Interim SC&A Review of the SEC Petition Evaluation Report for Petition SEC-00256: Pinellas Plant

**Contract No. 75D30119C04183
Document No. SCA-TR-2023-SEC001, Revision 0**

June 16, 2023

Figure 3. Comparison of tritium bioassays as a fraction of annual total

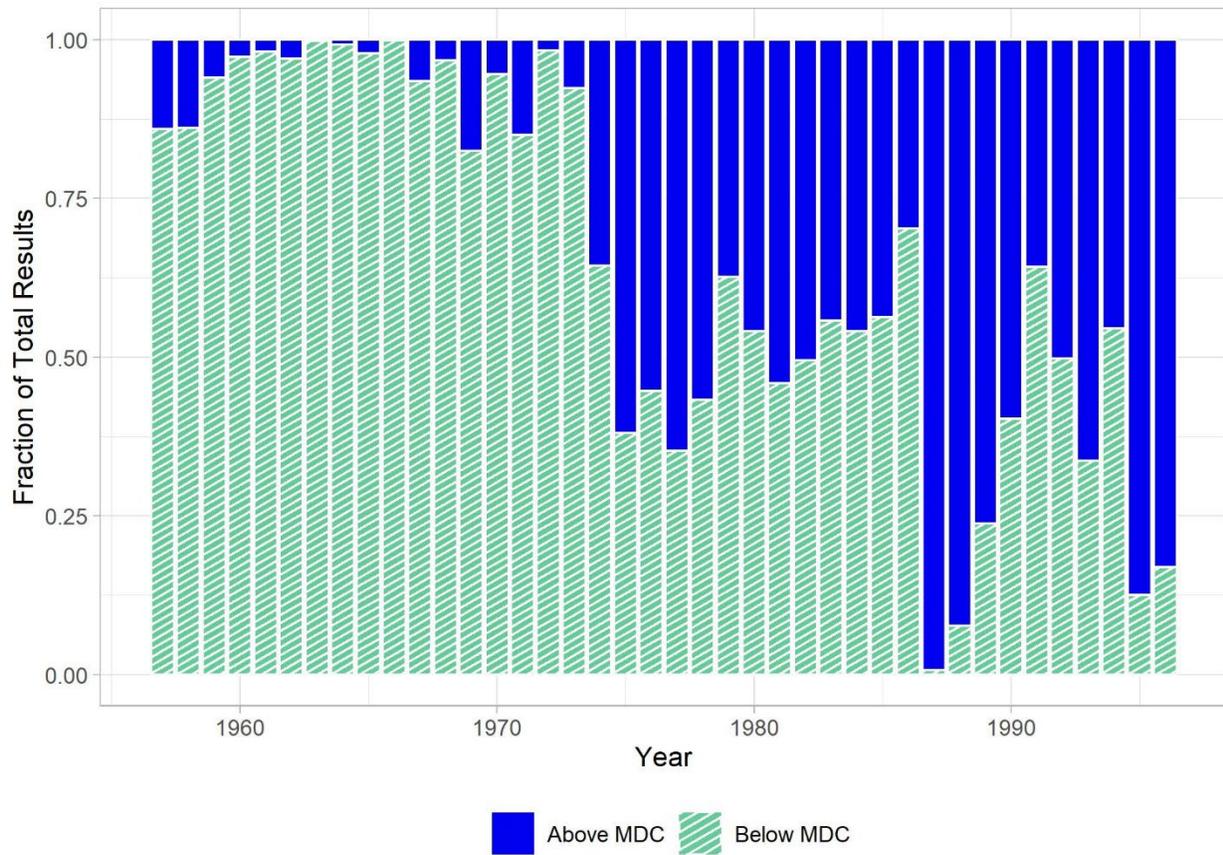
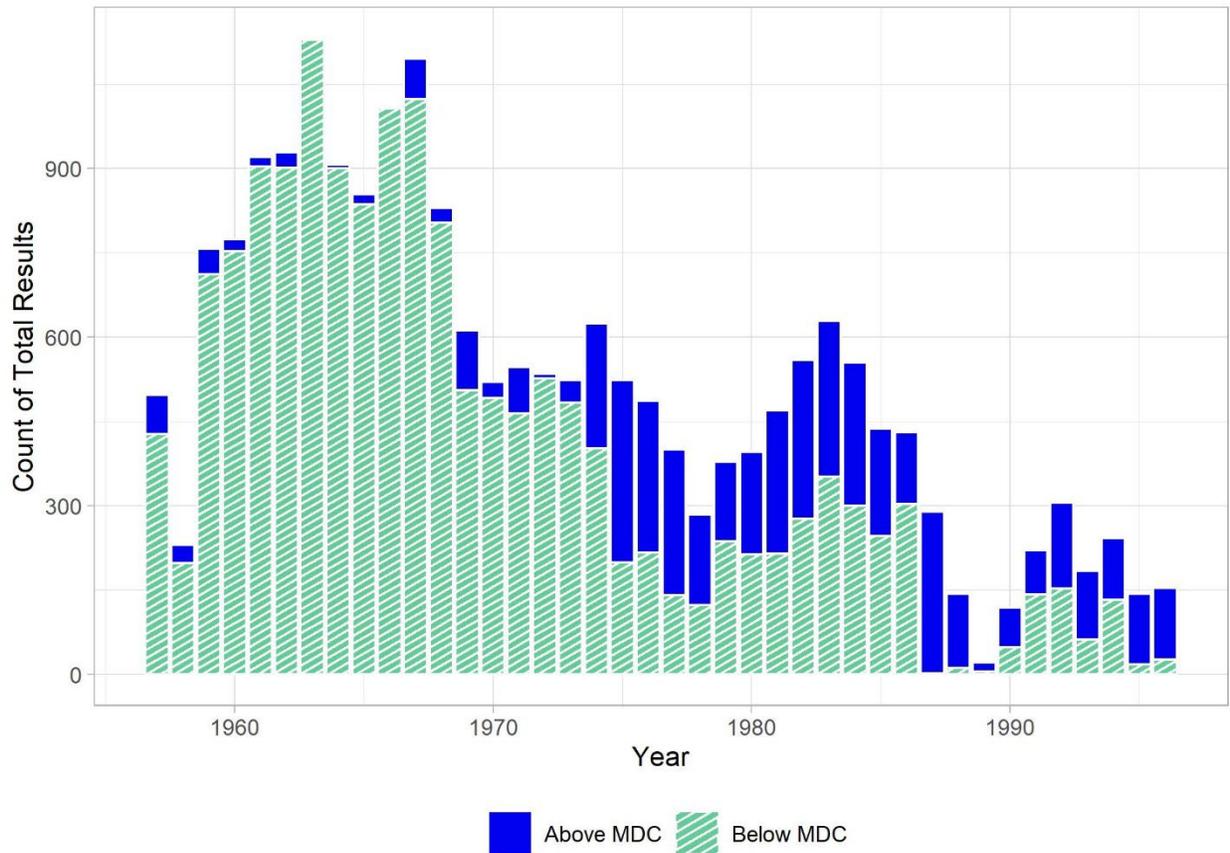
Observation 4: Lack of bioassay records for 1988–1990

From analyzing these results, the bioassay records from 1988 through 1990 stand out. Despite between 129 and 201 employees (table 3 and ER table 6-1) reportedly monitored by bioassays during these years, NIOSH only has monitoring records for 3–10 claimants per year (table 2 and ER table 6-2). According to the 1990 Tiger Team report, approximately 1,750 people were employed in 1989, suggesting that monitoring records are missing.

Figure 5. Comparison of tritium onsite to bioassayed individuals

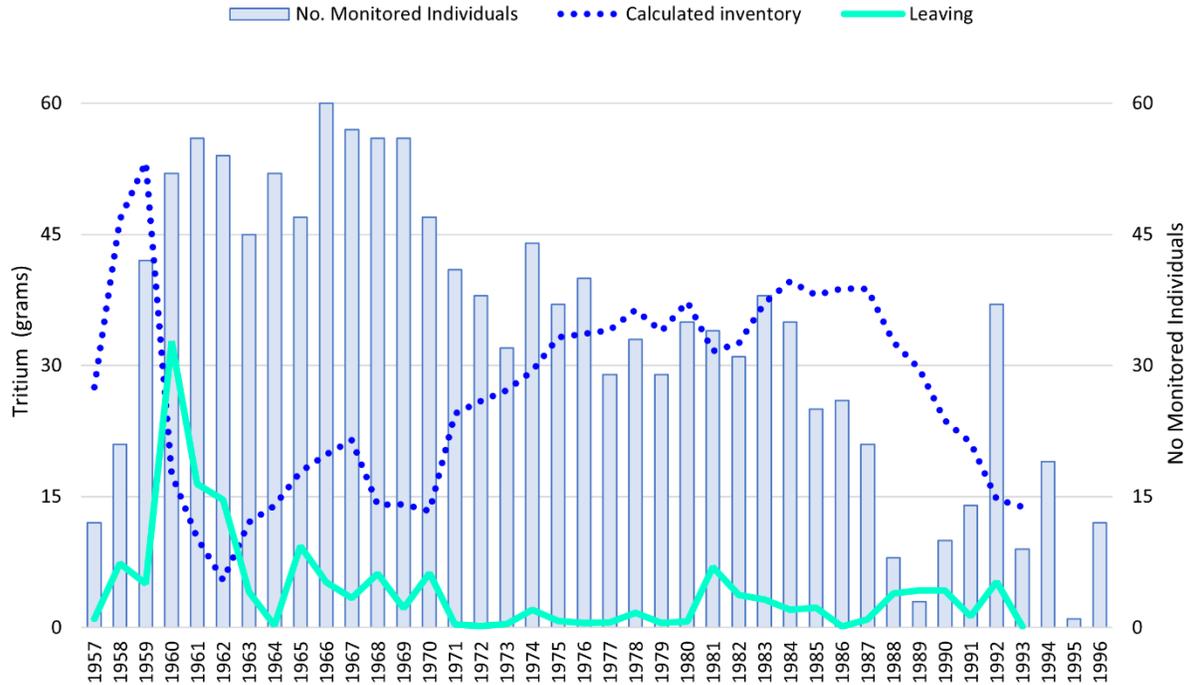
SC&A analyzed tritium inventories and throughput as an explanation of changes in bioassay monitoring. Biedermann (1994) provides an estimate of the historical tritium inventory at Pinellas. Inventory estimates for the period 1957–1993 were compiled by an Environmental Health Scientist for the National Center for Disease Control as part of an epidemiology feasibility study in September 1993 using plant tritium receipts, waste management disposal, and environmental monitoring records. These records were corrected to account for radioactive decay. Additionally, the scientist documented the tritium leaving the plant from product shipments, waste, air, and wastewater. These results are reproduced in figure 5 and compared with the monitoring data from table 2. As shown in figure 5, it is not clear that any correlation exists between the number of individuals monitored (per NOCTS) and the inventory or tritium throughput.
